# NSW Planning Assessment Commission Determination Report Alterations and Additions to Campbell's Stores, The Rocks (SSD 7056)

On 14 March 2017, the Planning Assessment Commission (the Commission) received from the Department of Planning and Environment (the Department) a State significant development application (SSD 7056) from Tallawoladah Pty Ltd (the Applicant) for alterations and additions to the existing Campbell's Stores building and its surrounding public domain at the Campbell's Cove foreshore at The Rocks.

Figure 2 – Photomontage showing the Bay 11 roof penetrations

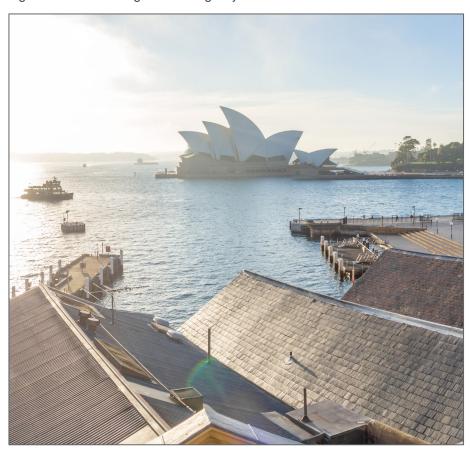
We understand the location and design of the centralised mechanical plant at Bay 11 continues to be a concern for the most sensitive receivers due to a perception that it will create noise, vibration, smell and fumes, and may impact on existing views of Sydney Harbour and the Opera House.

This additional information is provided in response to the public submissions received in relation to the revised SSD application, submitted to the NSW Department of Planning and Environment in October 2016. Specifically, a number of the submissions received raised concern regarding the location of the kitchen exhaust within Bay 11 and its proximity to the residential dwellings at 8 Hickson Road, as well as the Park Hyatt Hotel. Further, the public submissions suggest the kitchen exhaust will impact on residential amenity due to noise, vibration, smell and fumes, as well as visual impact from potential exhaust risers and noise baffles.

The proposed plant-room located within Bay 11 houses the kitchen exhaust, and approximately 50% of the building air conditioning plant. The kitchen exhaust and condenser discharges require openings in the Bay 11 roof to function. However, the impact of these openings is minimised by avoiding the use of cowls, and providing rainwater capture within the plant room.

As shown in the Architectural Drawings and Photomontages submitted with the SSD application, no ductwork will protrude above the roof of Bay 11 (refer Figure 2). Therefore, there will be no visual impact on the adjacent residential dwellings at 8 Hickson Road.

It is noted that the existing Bay 11 roof contains equipment on the southern side that is to be removed as part of the SSD application. The removal of these protrusions will improve the visual appearance of the Stores when viewed from the 8 Hickson Road residences.
